Gearsy Corridor Bus Rapid Transit Project

APPENDIX B: RESPONSE TO COMMENTS

FINAL ENVIRONMENTAL IMPACT REPORT (EIR)

SAN FRANCISCO COUNTY TRANSPORTATION AUTHORITY

Figure 1: Relationship of Van Ness BRT and Van Ness Corridor Transit Improvements Project

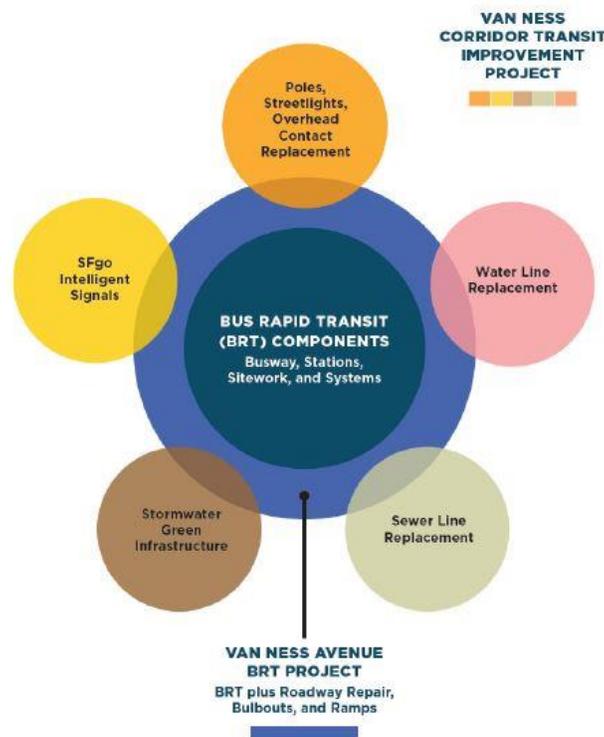
The transit portion seems to be more of a "while we're at replacing the sewer lines, let's "upgrade" the transit" because if SFMTA/SFCTA has already procured the buses for both BRT lines, they will still have the same number of doors to load and unload passengers so the total "dwell time" of roughly ONE MINUTE for the entire length of the GearyBRT corridor is not going to make much of a difference along with the supposed 8 minutes savings from the beach to downtown.

Again, **GearyBRT is a sewer and water replacement line project.** It is not about efficiency for the route, as stated above, with a speed that results in an overall bus rate of 4-6MPH over the entire 6-mile route.

Figure 2: Van Ness Avenue BRT Project Schedule

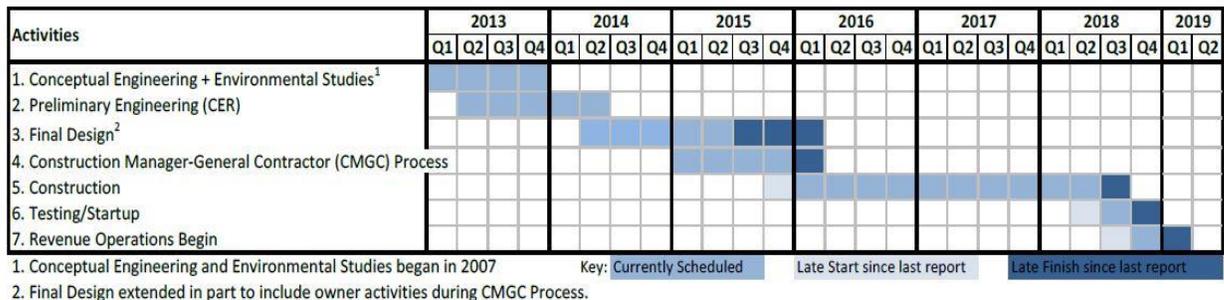
The GearyBRT DEIS/EIR is deficient in that although the VanNessBRT is listed as reasonably foreseeable impact in table 4.3-3, what is not shown is the analysis of the VanNessBRT Project as it falls behind schedule in relation to the GearyBRT. What are all the other transit projects listed

What are the environmental impacts to each of the CEQA categories with the delays of 1, 2, 3, 4, 5 years? 10 years? 20 years? This is incomplete in the DEIS/EIR and needs to be included.
